**HILL EAST PHASE II DEVELOPMENT  
Request For Proposals (RFP)**

Questions and Answers

Date: January 11, 2020

ENGINEER'S SEAL & SIGNATURE	
SITE PLAN	
ROADWAY GRADING	
HILL EAST REDEVELOPMENT	
Date	Revisions
Drawn By	
Designed By	
Checked By	
Date	
Scale	1" = 100'
Sheet	14 of 48

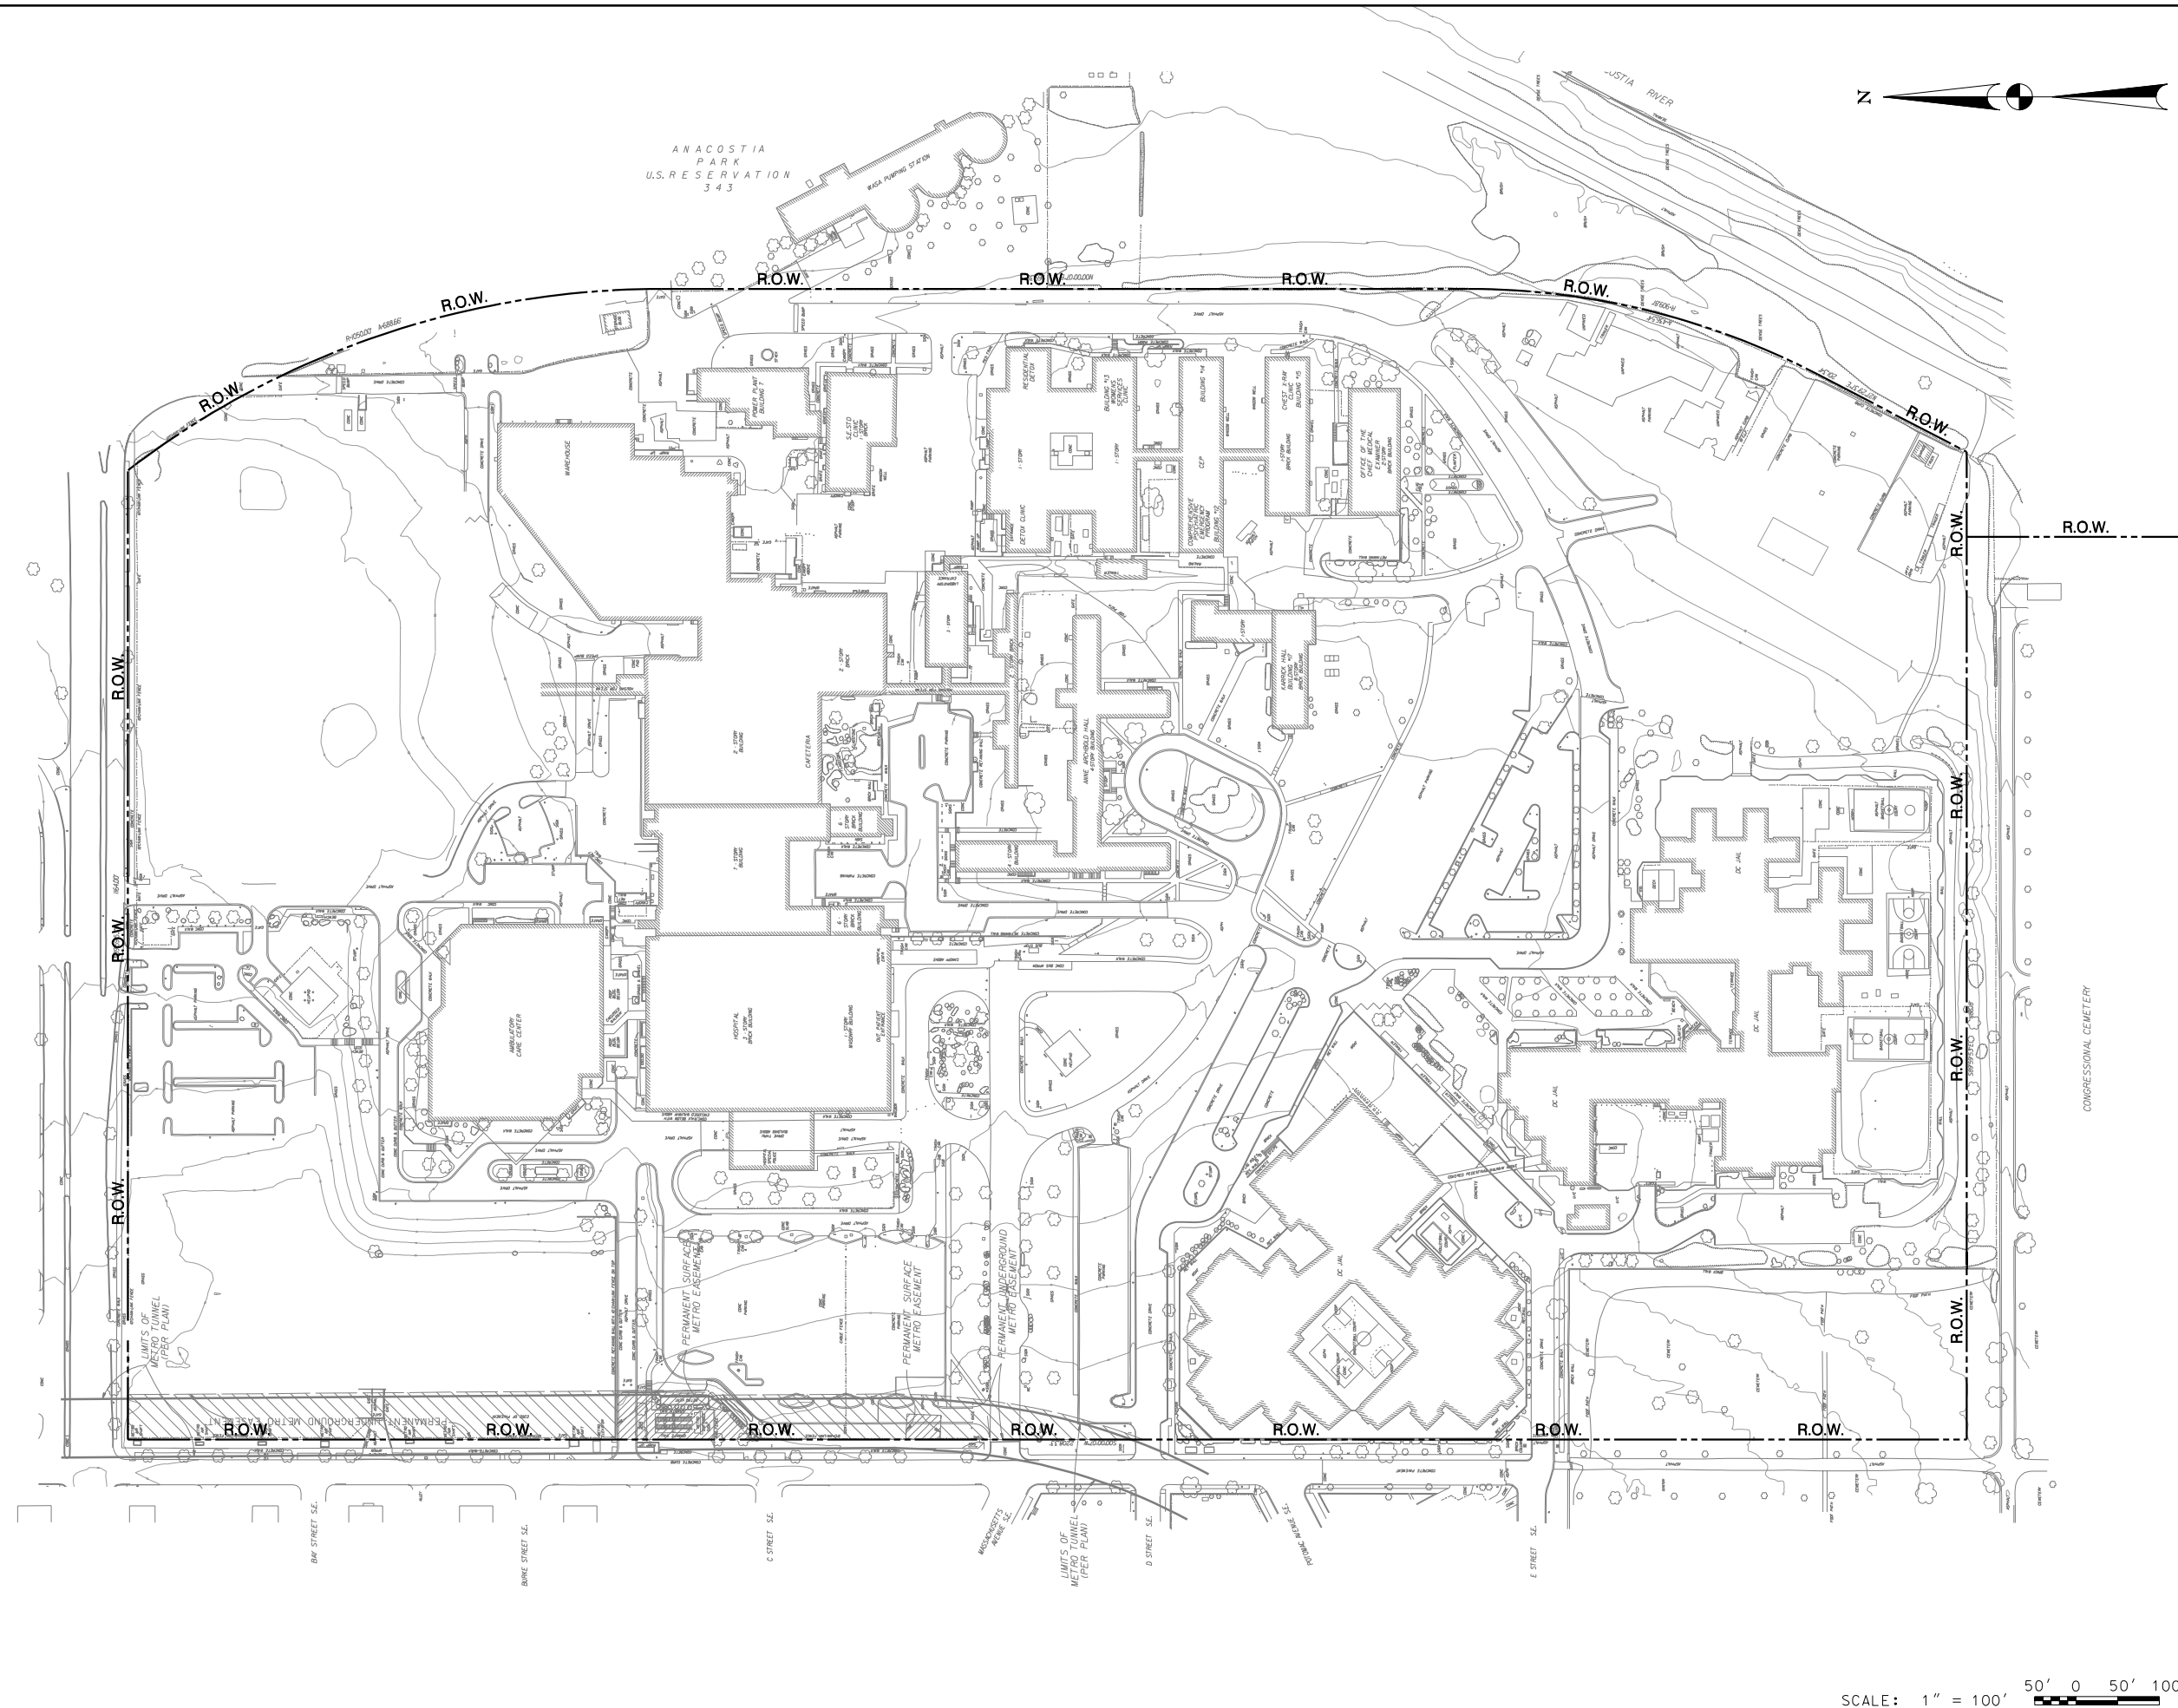
**Question 28:** Please provide CAD files of existing conditions (e.g. survey CAD or PDF plans of site).

**Answer 28:** Attached is the PDF copy of the “Hill East Existing Conditions Map (April 2007)” to serve as a general guide. Please note that DMPED makes no representations or warranties as to the accuracy of the information contained in the map and the conditions that may have changed. The selected development team will be solely responsible to undertake their own independent due diligence on the applicable Development Parcel and determine the accuracy of the current site conditions.
